**2803 EDGEWATER VARIANCE REVISION NOTES : Highlighted Points**

2803 EDGEWATER DRIVE

EDGEWATER VARIANCE

191023

REVISED IMPERVIOUS COVER TABULATIONS BOA HEARING 11/07/19

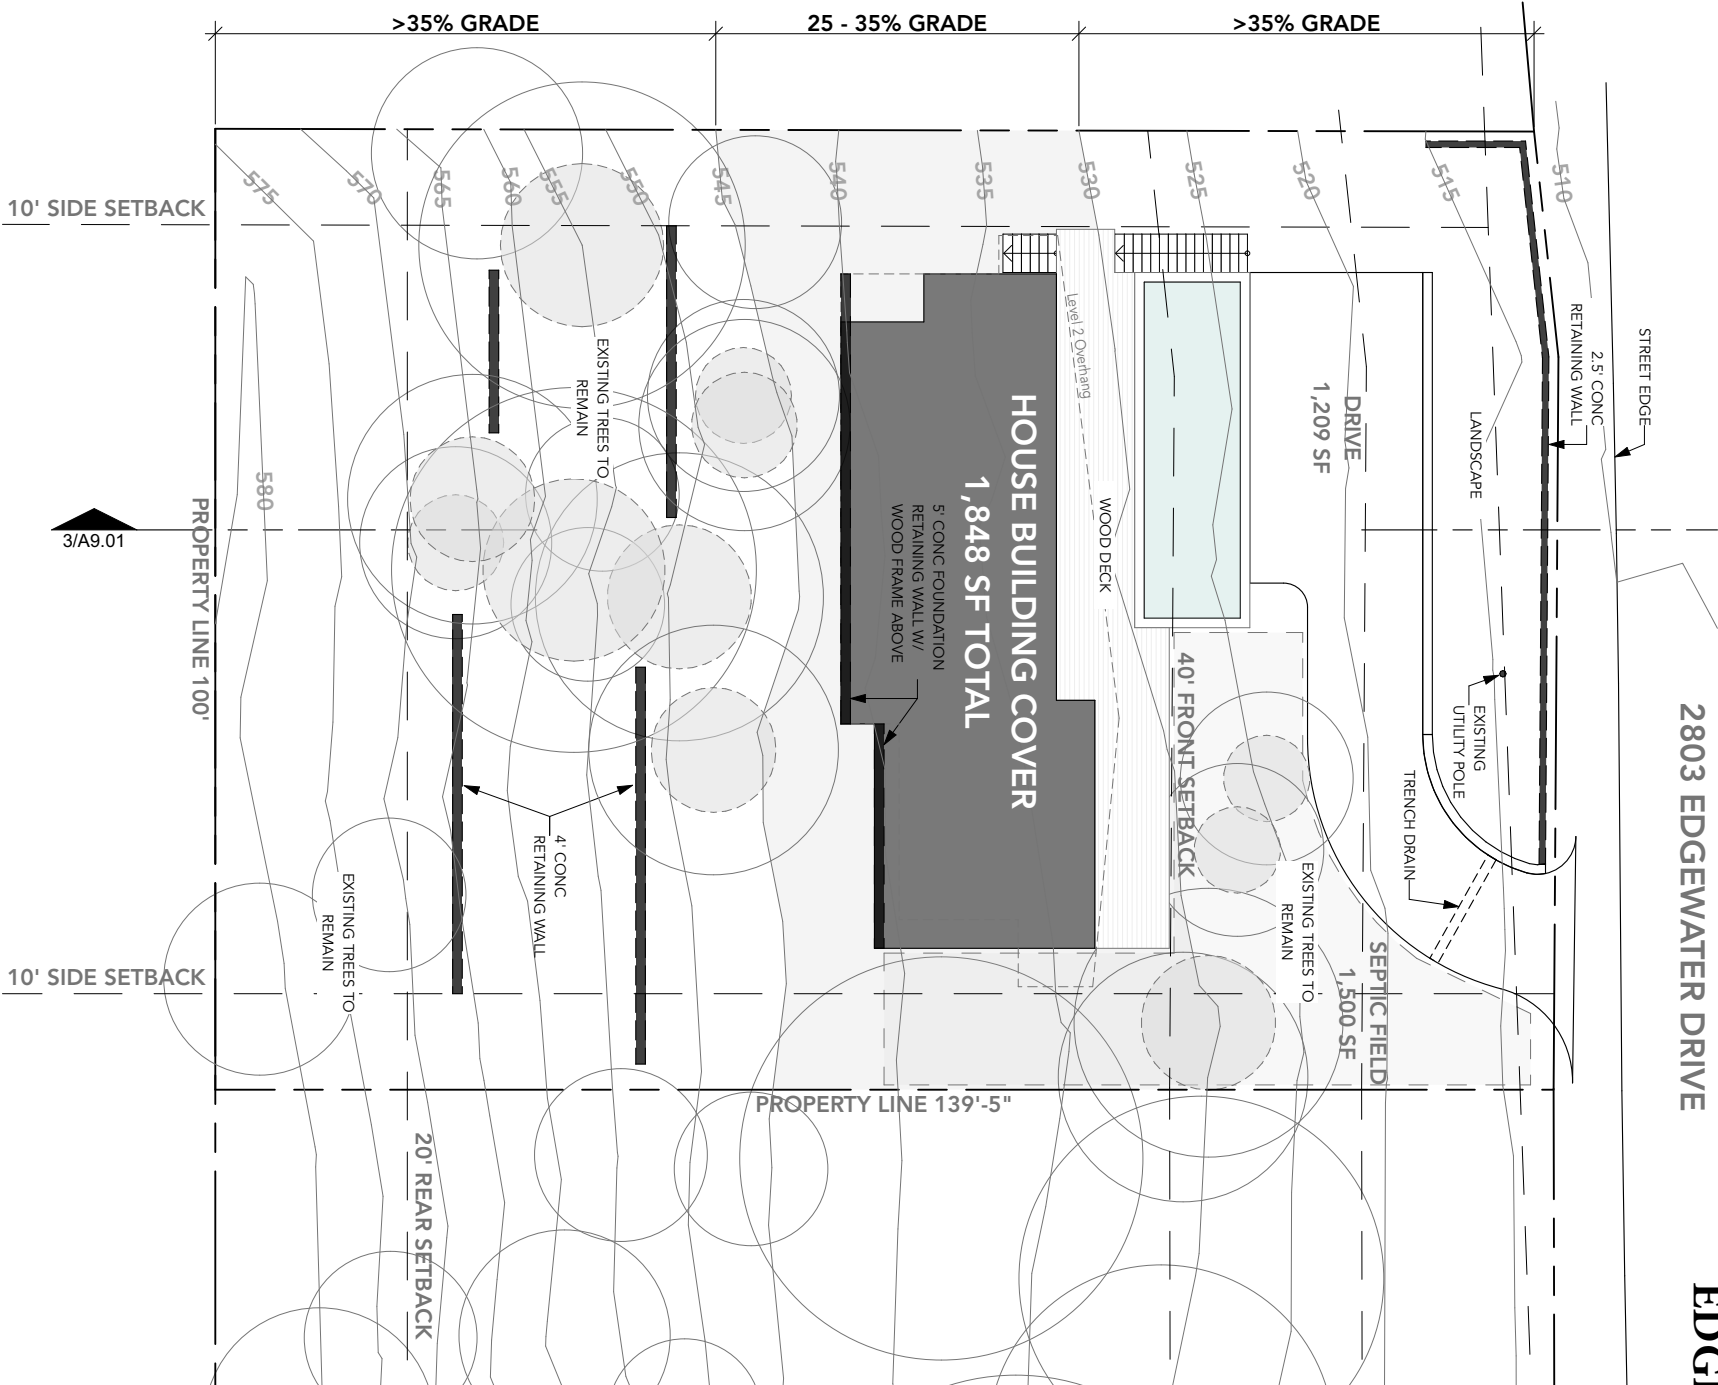
1. Please include Neighbor Letters / Meeting Feedback
2. Footprint of house has decreased from 2,233SF to 1,848 SF
3. Impervious cover at 25%-35% Zone has decreased : from 66% to 59%

4. Impervious cover Over 35% Zone has decreased : from 29% to 17%
5. Detention is not required per residential code - we are proposing detention
6. Structural Engineer has provided a letter indicating that Pier and Beam is not a viable solution for this project.

SLOPE GRADE	SF PER ZONE	ALLOWABLE % PER ZONE	PROPOSED % PER ZONE	ALLOWABLE SF PER ZONE	PROPOSED SF PER ZONE
0-15%	-	35%	-	-	-
15-25%	-	10%	-	-	-
25-35%	3,892 SF	5%	59 %	196 SF	2,279 SF
OVER 35%	10,043 SF	0%	17 %	0 SF	1,676 SF
			TOTAL	196 SF	3,811 SF

SITE SECTION @ HOUSE

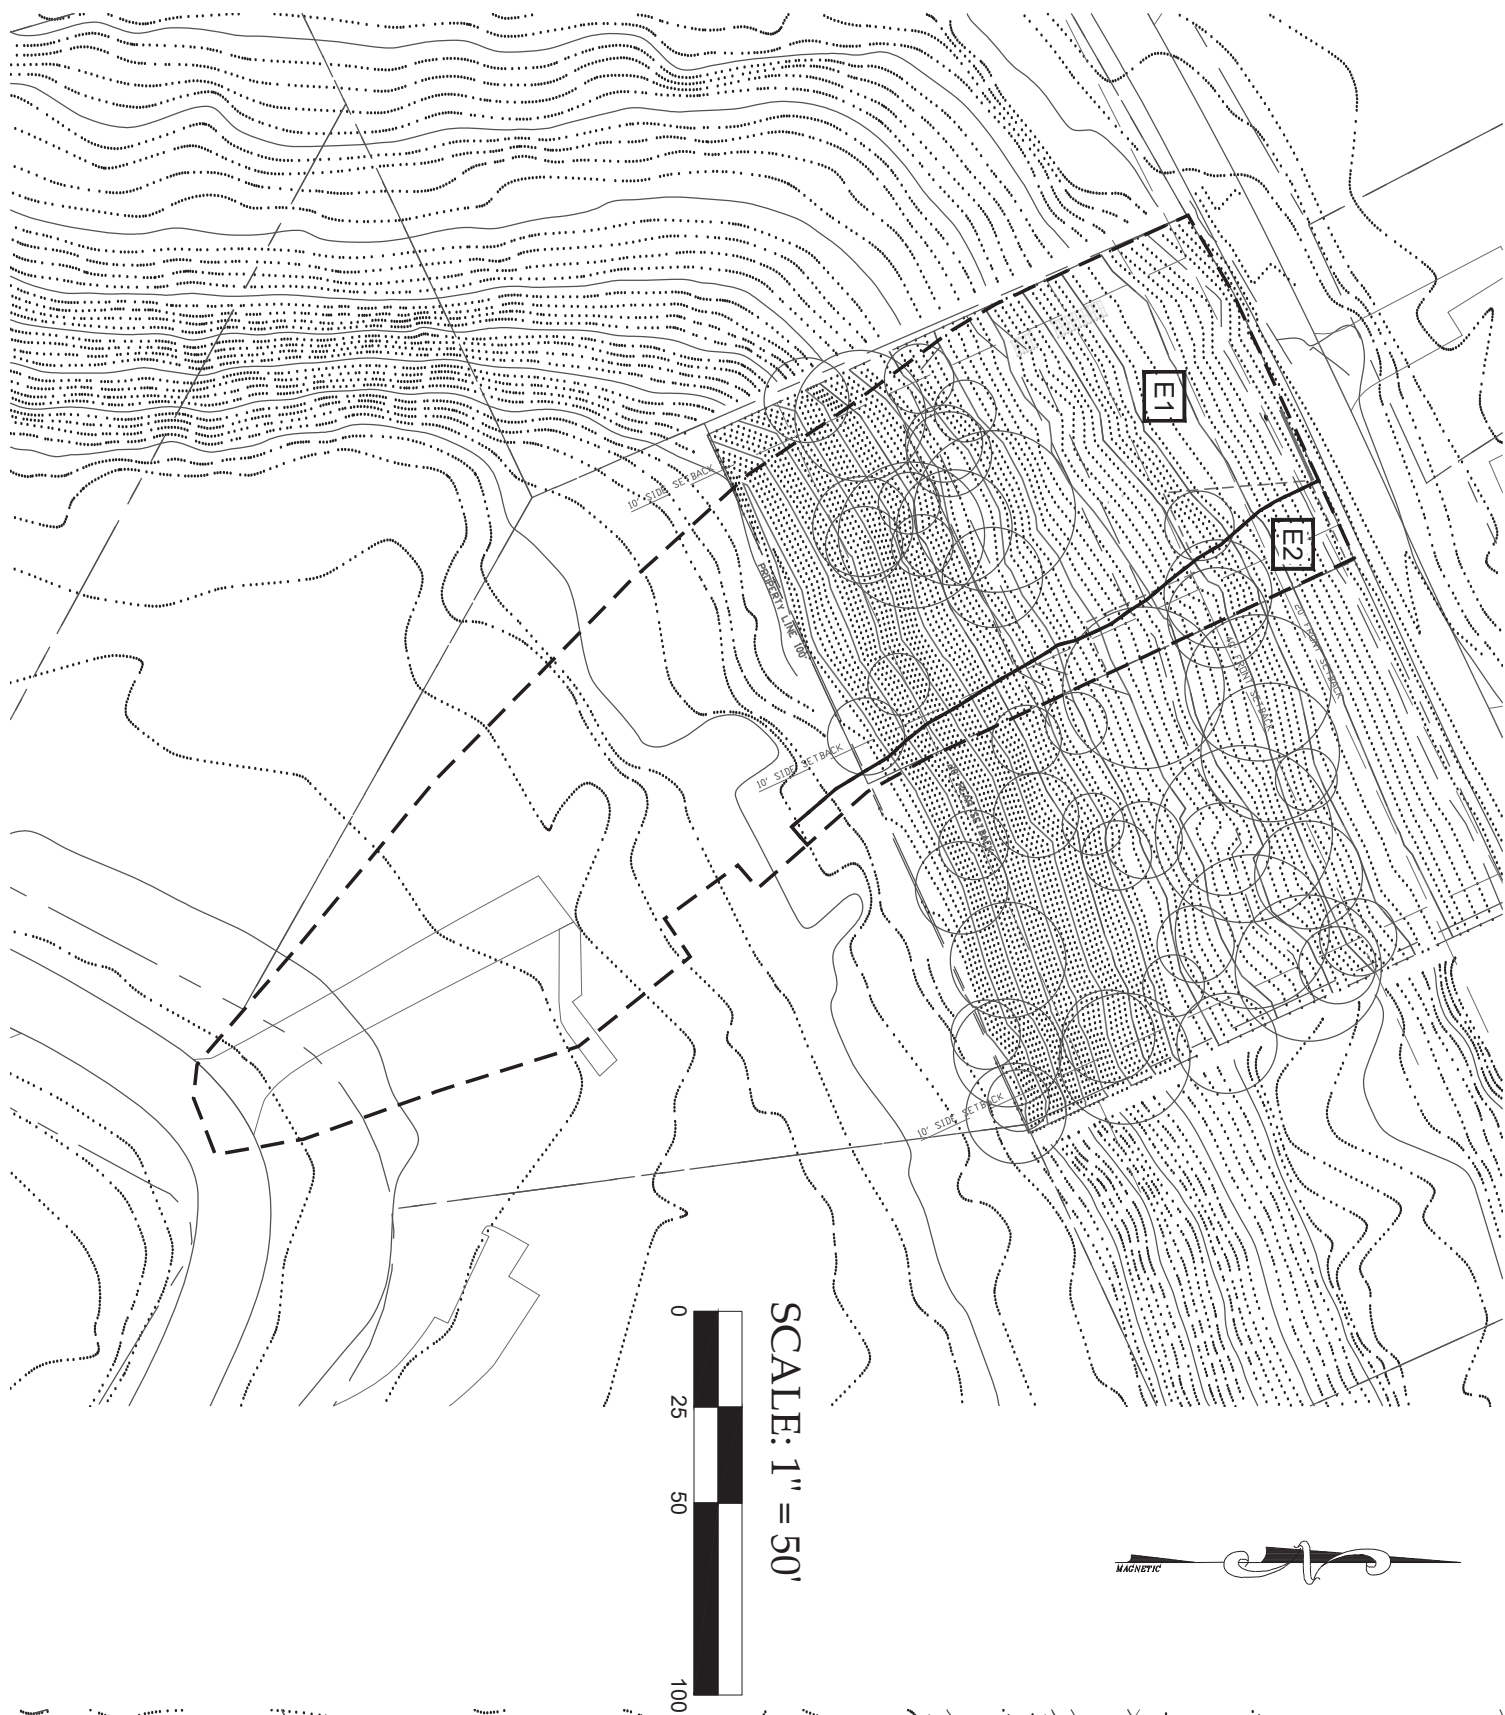
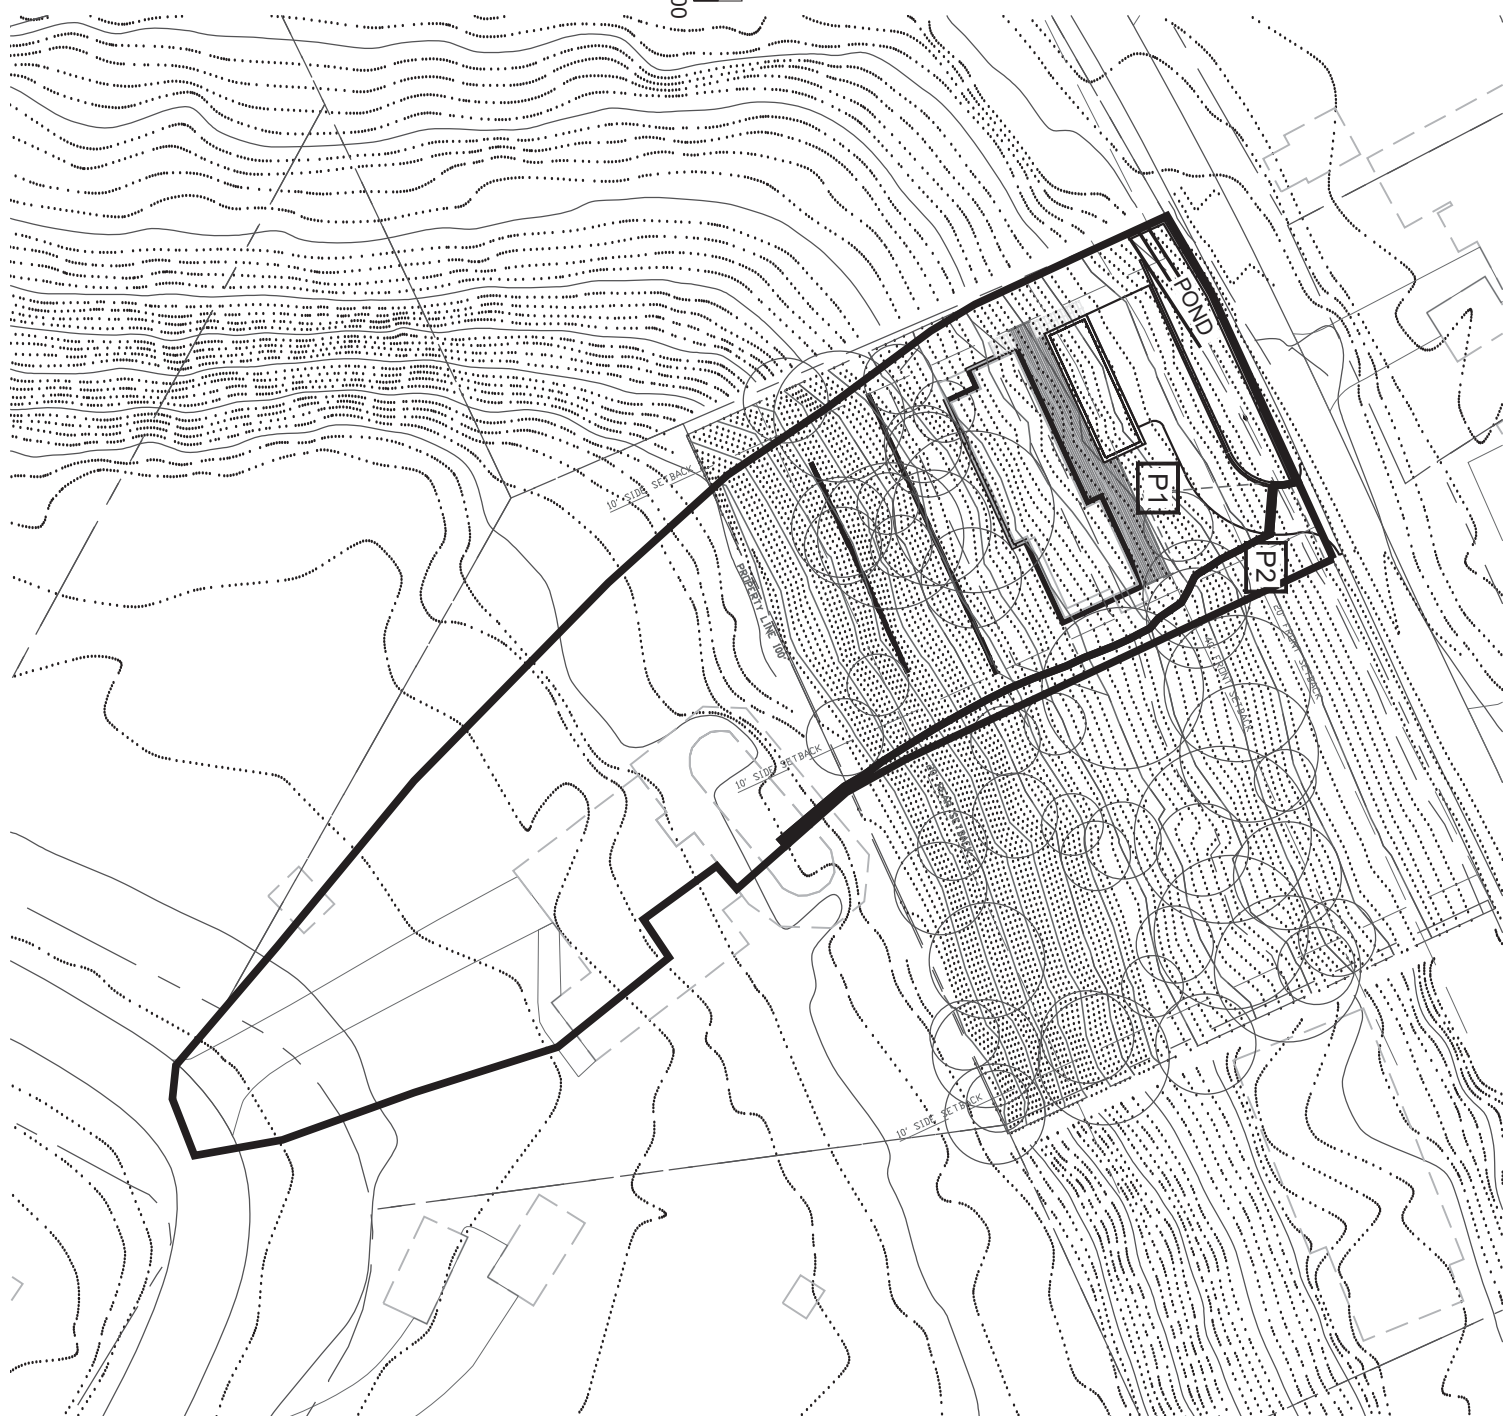
9. Cut and Fill minimized and balanced per section.
10. Surveyed Trees are in drawings indicating trees to remain and trees to be removed.
11. Retaining walls are limited to 4 feet per code

12. Foundation retaining walls are allowed to rise above 4 feet per code.
13. Civil Drawings - are present indicating drainage strategy and zero impact to adjacent neighbors. Run-Off to the street is minimized to less than a water-sprinkler. Existing conditions have been improved with our drainage plan.

2 PROPOSED DRAINAGE AREA MAP  
SCALE 1"=50'

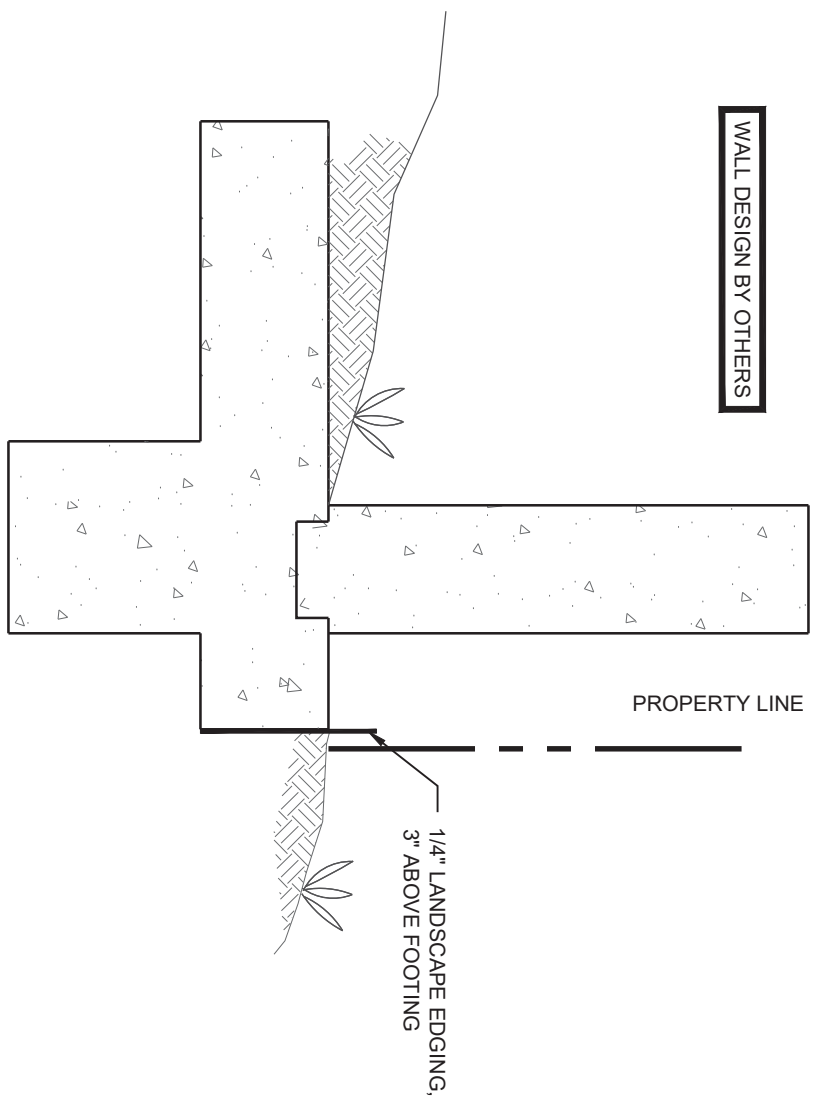
13. Civil - The proposal for the construction of a home on this lot is to exceed current practice and construct a landscape wall which will serve as a “detention” wall to slow any increase in the peak run-off caused by the impervious cover. As shown in the computations, the computed release from the proposed “pond” will be the same or less than that which exists. Release from this “pond” is expected to spread and pass down the roadway as currently exists but also thick landscape edging will be included on the downslope side of the wall to further the discharge mimicking the existing condition.

14. Civil - The construction of a planned home on this lot was computed to increase the peak discharge to Edgewater by only 0.2 to 0.3 cfs in the 500-year condition (3 to 5 percent, or arguably the equivalent of 3 or 4 lawn sprinkler zones going off at the same time).
